RE: Town of Hull Well Impact Claims

As per your request, I have reviewed the claims of impacts to private wells from the operation of City of Stevens Point Well 11 as described in a report from Montgomery Associates Resource Solutions (MARS) prepared for the Town of Hull dated October 9, 2014.

**Figure 1: Location of Well 11, Replaced Wells, and City of Stevens Point Monitoring Wells (Source: MARS 10/9/14 Technical Memorandum to Town of Hull)**

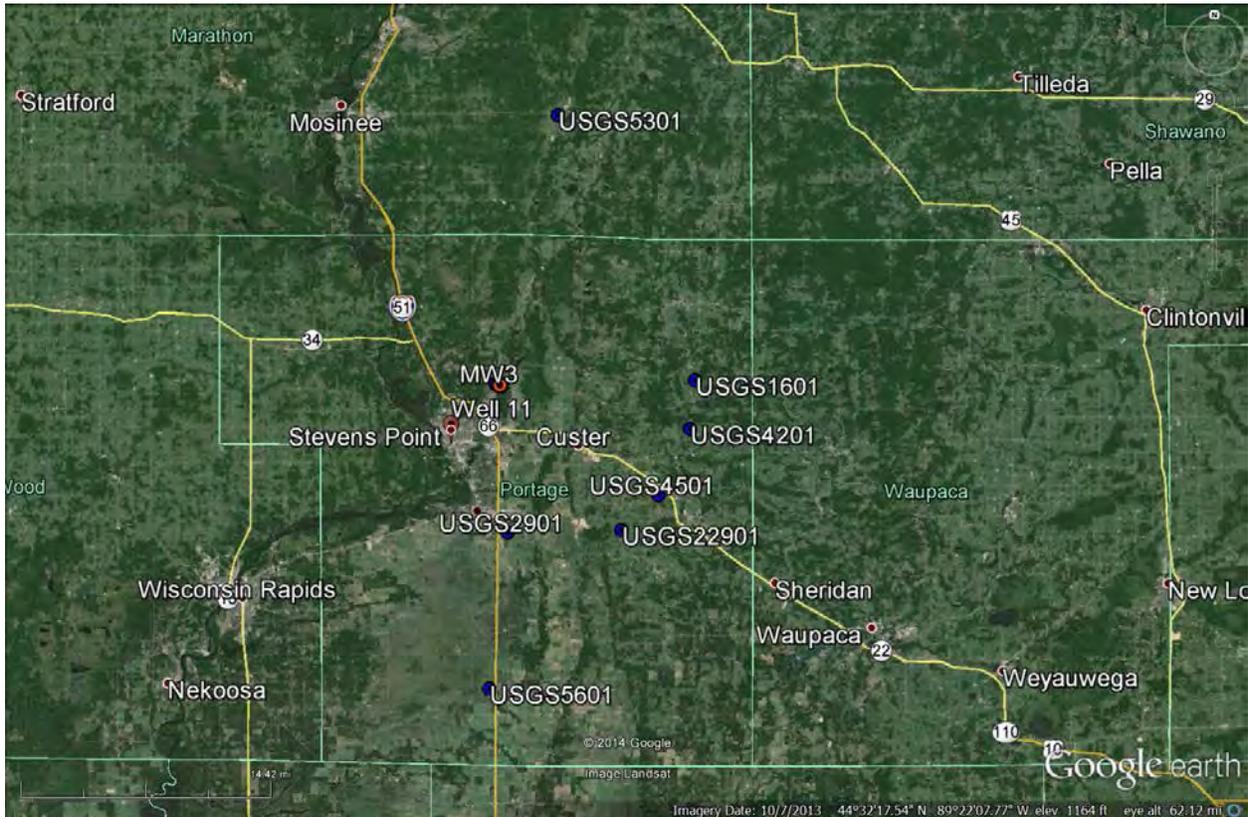
The MARS report described 29 wells that were replaced from May 2012 to August 2014 due to capacity problems. Some of the wells were nearly a mile from Well 11. They reported that "Many of the replaced wells had bottom elevations near the water table". In our meeting with the Town in November, Town officials related that many of the wells were sand points driven a few feet below the water table. Wells of such construction can lose the capacity to produce water if the water table drops too close to the top of the sand point screen. In addition, plugging caused by natural mineral encrustation or biological growth can plug the point screens and cause additional drawdown within the well point that can cause the sand point to break suction and stop producing water.

**Figure 3: Depth to Water in USGS Monitoring wells and MW3**

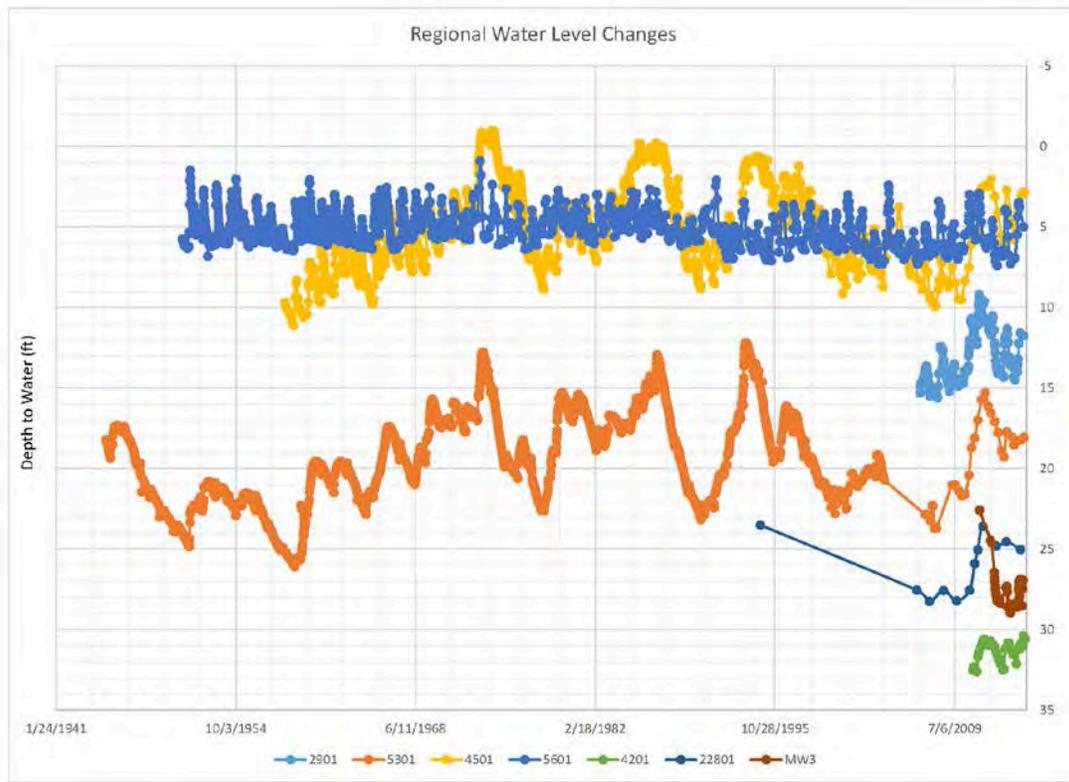
**Figure 3** is a plot of the depth to water for the seven USGS monitoring wells and City monitoring well MW3 for the period of record. The USGS wells lie about 7 to 15 miles from Well 11 and are located in areas with land use that ranges from predominantly forest to predominantly irrigated agriculture with some areas of mixed forest and agriculture. The USGS wells provide independent observations of groundwater levels that are miles beyond any potential impacts from Well 11 and reflect regional changes in groundwater storage. The data shows that water levels in the aquifer on a regional basis naturally vary by several feet in response to seasonal and annual changes in recharge and regional pumping.

**Figure 4: Plot of Changes in Ground Water Levels for the Last 5 years**

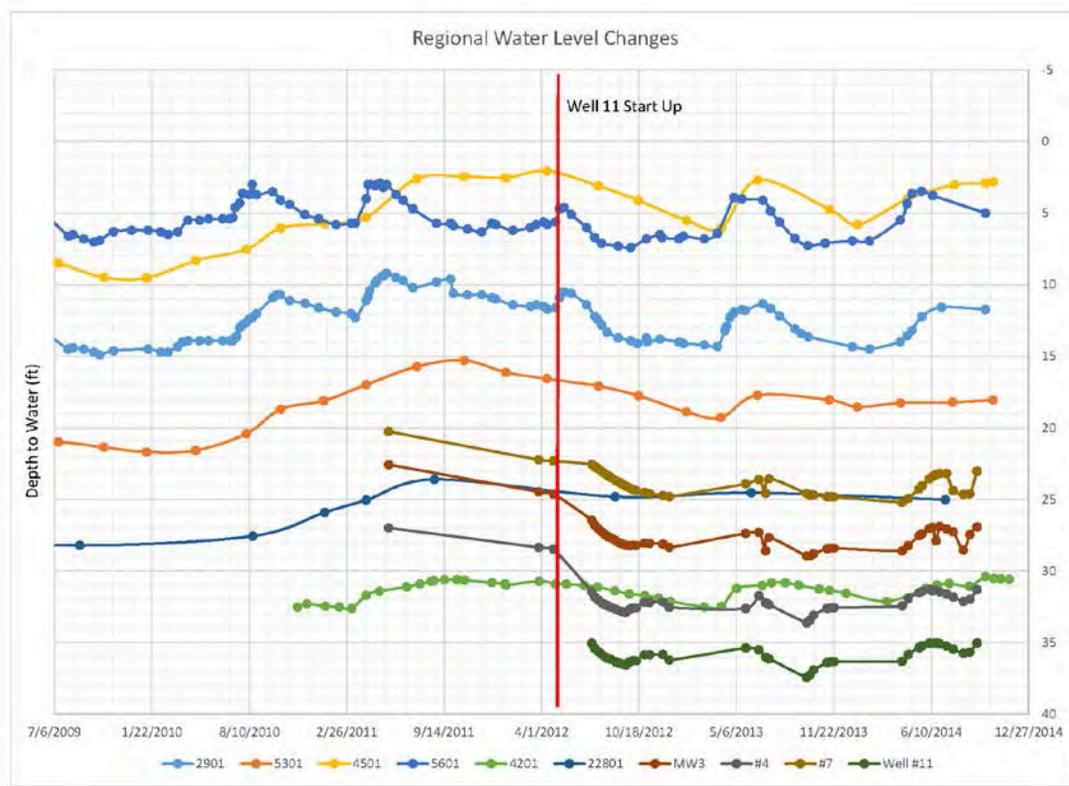
**Figure 4** is a plot of the depth to water for the USGS monitoring wells, Well 11, and the three closest City monitoring wells to Well 11 for the last five years. Groundwater levels gradually increased by about three to five feet in all wells from early 2010 through the end of 2012. Water levels in all wells began to decline in the spring of 2012, coincidentally about the time Well 11 began pumping. However, the decline in water levels occurred in all wells, even though the USGS wells are well beyond the limits of any potential pumping effects of Well 11. The data shows the decline in water levels was regional in nature and was not specific to the area around Well 11.

Groundwater levels generally declined throughout 2012 and recovered quickly in the spring of 2013. The decline in groundwater levels seen in the City monitoring wells near Well 11 looks very similar to the declines observed in several USGS monitoring wells including USGS MW2901 and USGS MW5601. USGS MW5301 and USGS MW4501 showed similar magnitudes of variation but the measurement frequency was lower so it is not known if the rate of decline was similar to the City monitoring wells.

**Figure 5: Cummulative Precipitation Vs. Normal Precipitation for 2012 and 2013 in Wausau, Wisconsin**

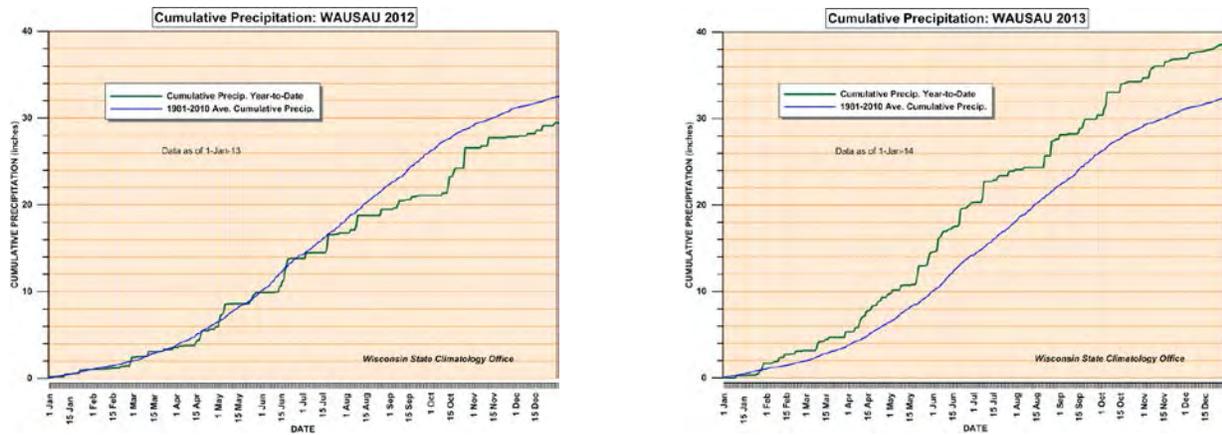
**Figure 5** shows the cumulative precipitation plotted against the normal precipitation for 2012 and 2013 at a weather station in Wausau, Wisconsin. The data demonstrates that the summer and fall of 2012 were abnormally dry.

Precipitation dropped below normal levels in June and trended below normal levels for the remainder of the year. Precipitation recovered to above normal in early 2013 and remained above normal for the rest of 2013. These observations suggest that the regional decrease in water levels in the summer and fall of 2012 were a natural response to a hot, dry summer. The rapid rise in water levels in the spring of 2013 was due to heavier than normal winter precipitation that generated a strong groundwater recharge event during the spring snow melt and heavier than normal precipitation for the rest of 2013.

**Figure 6: Change in Water Level of USGS MW2901 vs. MW3 Since Well 11 Start Up**

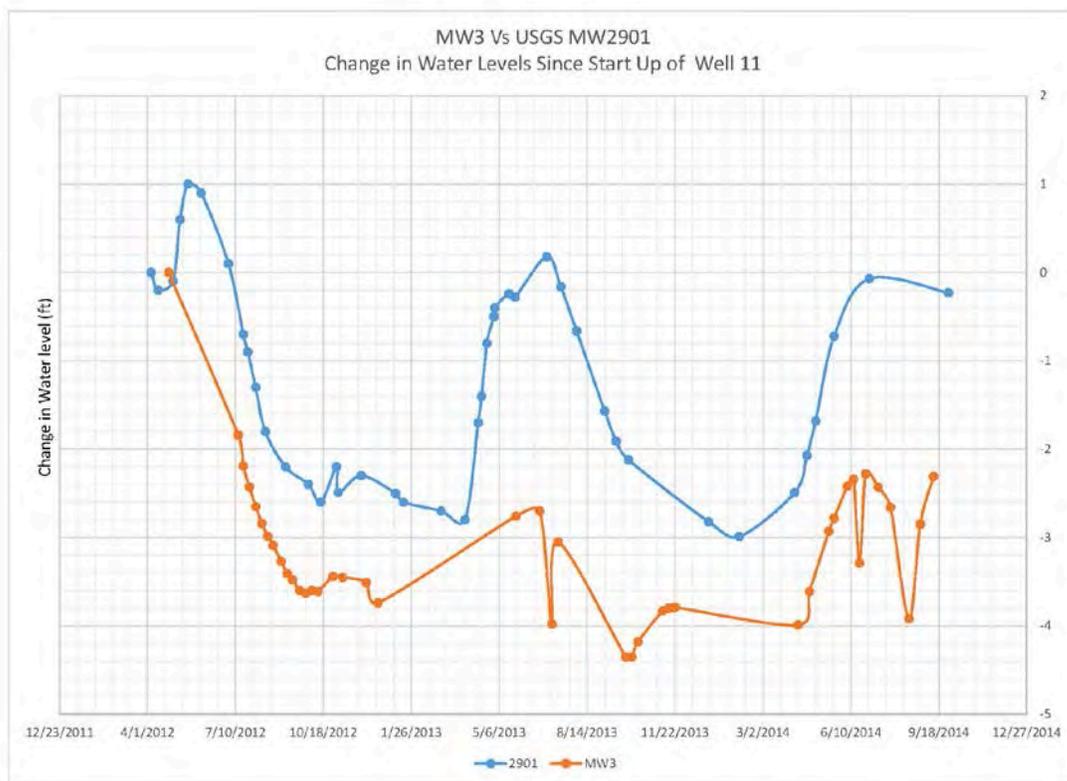
**Figure 6** is a plot of the change in groundwater level since the startup of Well 11 for MW3 and the closest USGS monitoring well, USGS MW2901. The plot was calculated by setting the water level in each well from March 2012 to 0 and plotting the rise or decline in subsequent readings.

The maximum change in groundwater levels in MW3 since Well 11 started pumping is about 4 feet. This represents the maximum impact that could be attributed to Well 11 if there were no other factors affecting water levels in the aquifer. However, the regional water level shows that water levels declines of a similar magnitude were occurring throughout the aquifer over an area of miles around the well during the same time period. This indicates that a significant portion of the observed decline in water levels around Well 11 was due to regional factors and the actual impact is significantly less than 4 feet.

The plot also shows that the changes in groundwater levels in the two wells generally track each other from the point of startup of Well 11 with the exception of a downward bias of about one to two feet in MW3. This is direct physical evidence that the groundwater levels around MW3 were one to two feet lower than expected. Most of this difference is probably due to pumping at Well 11. While simplistic, this estimate is based on field data and is more reliable than estimated values. Changes much lower than this magnitude are difficult to detect or accurately measure. Based on the available data, it is my opinion that the drawdown in the aquifer at MW3 caused by Well 11 after pumping 2.8 mgd for over two years was clearly less than 4 feet, most probably less than 2 feet, and could be on the order of one foot. Drawdown from a pumping well declines logarithmically with distance from the well. The magnitude of drawdown from Well 11 would be substantially less beyond MW3 farther from Well 11.
